HISTORIC AND DESIGN REVIEW COMMISSION

HDRC CASE NO: 2019-352
ADDRESS: 1021 N PALMETTO
LEGAL DESCRIPTION: NCB 1369 BLK 6 LOT N 46 FT OF 8 & 9 ARB A-1
ZONING: R-4,H
CITY COUNCIL DIST.: 2
DISTRICT: Dignowity Hill Historic District
APPLICANT: James Benfield/BENFILED REAL ESTATE LLC & G6 HOMES LLC
OWNER: James Benfield/BENFILED REAL ESTATE LLC & G6 HOMES LLC
TYPE OF WORK: Amendment to previously approved siding specifications
APPLICATION RECEIVED: May 16, 2019
60-DAY REVIEW: July 15, 2019
CASE MANAGER: Stephanie Phillips
REQUEST:

The applicant is requesting a Certificate of Appropriateness for an amendment to allow for the use of faux wood Hardie siding in lieu of the previously approved smooth Hardie siding on the new construction located at 1021 N Palmetto.

Photographs

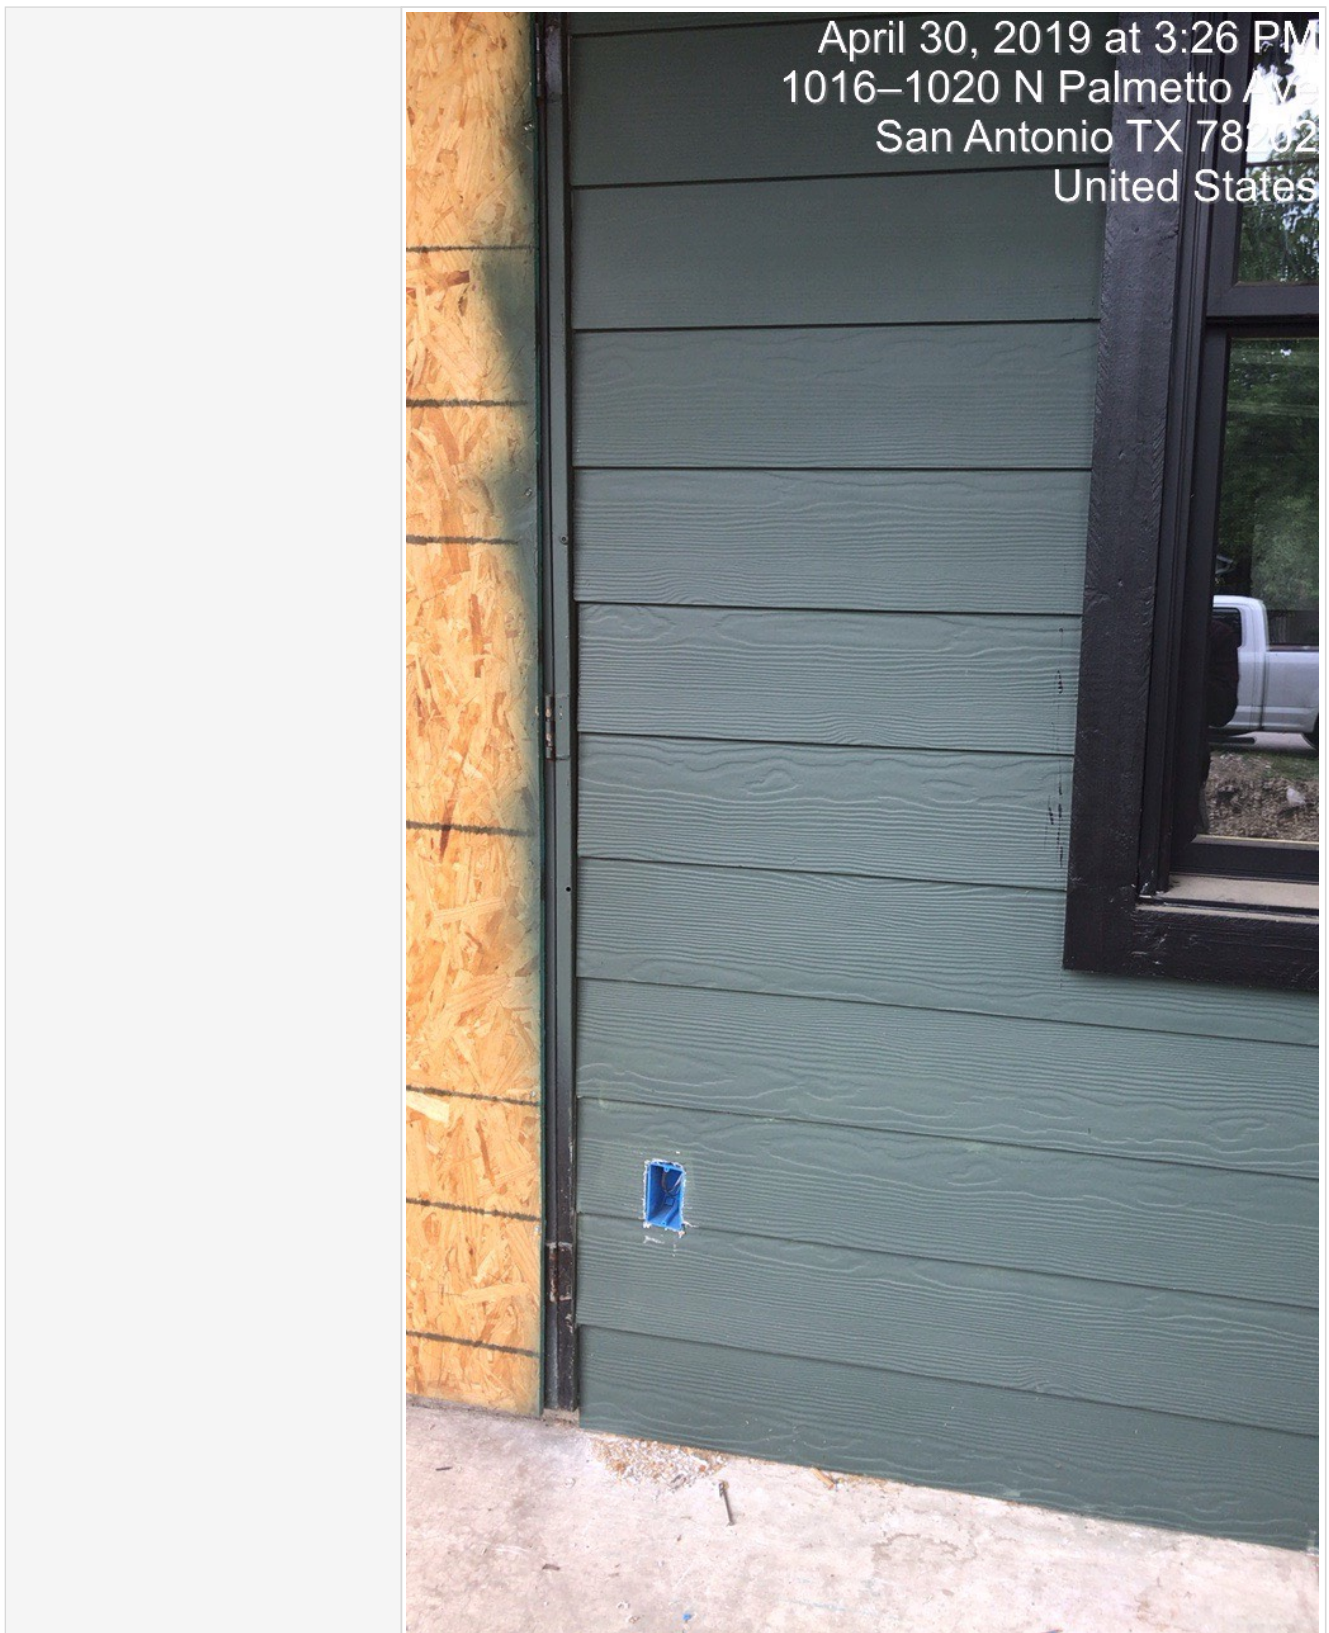
Date	04/30/2019
Time	03:39 PM (-5 GMT)
Context	citizen report
Present Staff	Huy Pham, Edward Hall
Present Individuals	None
Types of Work Observed	New Construction
Amount of Work Completed	50%
Description of work	Installation of siding material inconsistent with approval.

Violation Type	Beyond scope of Certificate of Appropriateness (Code 35-451h)
OHP Action	Posted "Notice of Investigation"
Will post-work application fee apply?	No
